SERVICE BULLETIN SB-67

SUBJECT: R44 II Fuel Hose Supports

ROTORCRAFT AFFECTED: R44 II Helicopters S/N 10001 thru 12566.

FIGURE 1

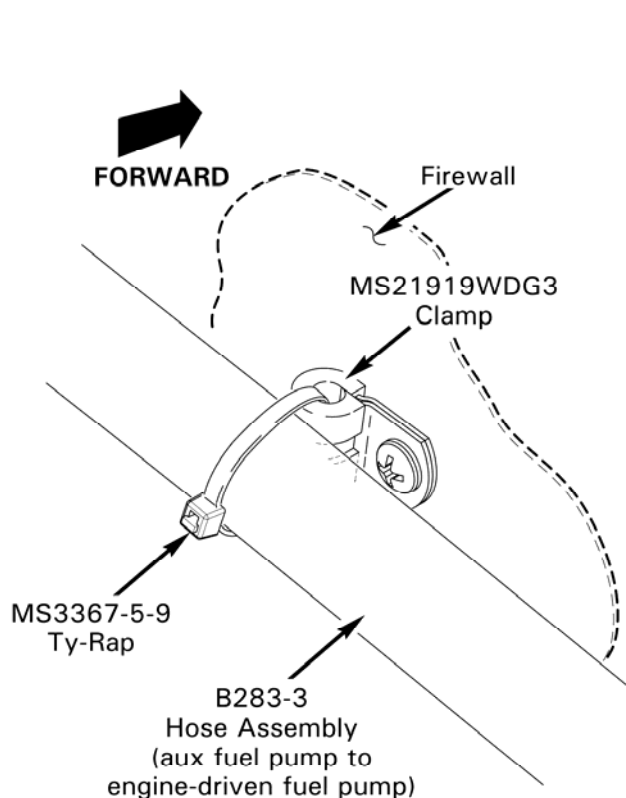
BACKGROUND: In an accident, the engine may shift relative to the airframe structure and cause fuel hose damage. This service bulletin requires replacing support clamps with ty-raps on two fuel hoses. Under high load, the ty-raps will break to provide fuel hose slack, reducing the likelihood of a post-accident fuel leak.

4. Refer to Figure 1. Attach MS21919WDG3 clamp to firewall using retained hardware, with fastener head toward hose as shown.
5. Insert MS3367-5-9 ty-rap through installed clamp and around B283-3 hose assembly. Cinch ty-rap until snug without overtightening and trim ty-rap tip flush with head.

FIGURE 2

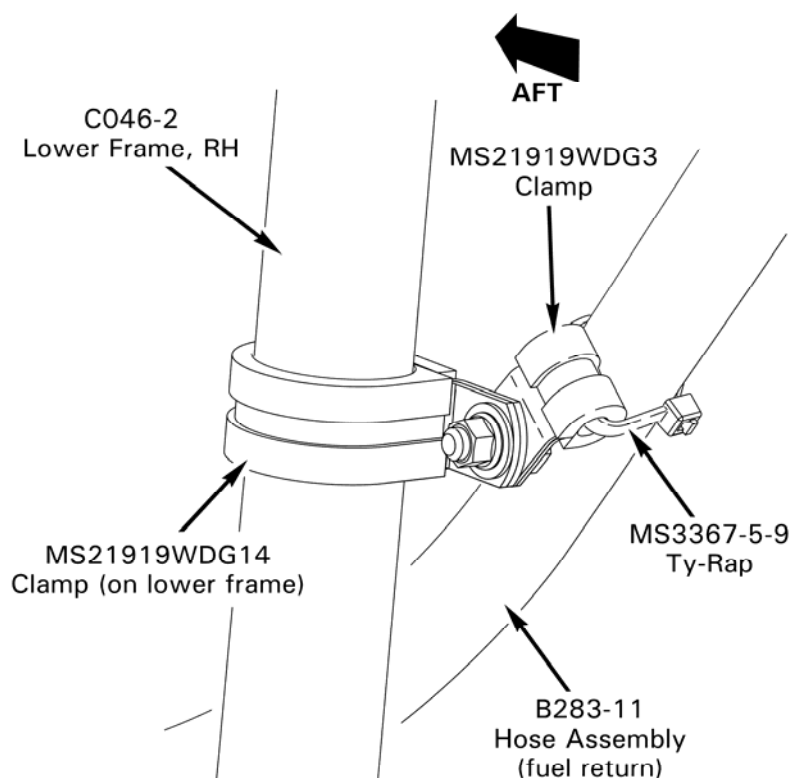
7. Refer to Figure 2. Attach MS21919WDG3 clamp to MS21919WDG14 clamp using retained hardware, with fastener head toward hose as shown. Torque nut to 37 in.-lb. Remove temporary safety wire, if used.
